UNITED STATES PATENT AND TRADEMARK OFFICE

| APPLICATION NO. | FILING DATE | FIRST NAMED INVENTOR | ATTORNEY DOCKET NO. | CONFIRMATION NO. |
|---|-------------|----------------------|---------------------|------------------|
| 10/586,386 | 10/02/2006 | Gunther Leising | 00366.000214 | 1805 |

Office Action Summary**Application No.**

DETAILED ACTION

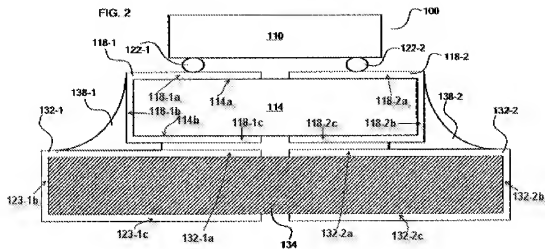
As for claim 9, Bhat et al. show in Fig. 2 and related texts (see, i.e. [0023]-[0026]) a light emitting diode, comprising at least one light emitting diode die 110, arranged on a light emitting diode printed circuit board 114 by means of a die attach 122-1/122-2, the light emitting diode printed circuit board 114 comprising at a bottom surface 114b thereof rear side contacts 118-1b/118-2b,

wherein the rear side contacts 118-1c/118-2c at least partially overlap with contours of the light emitting diode die 110 and are formed in such a way as to overlap with at least half of the bottom surface 114b of the printed circuit board 114, and

wherein the printed circuit board 114 comprises a plurality of through-contacts 118-1b/118-2b thermally and electrical connecting the rear side contacts 118-1c/118-2c

to contact areas 118-1a/118-2a formed on an upper surface 114a of the printed circuit board 114.
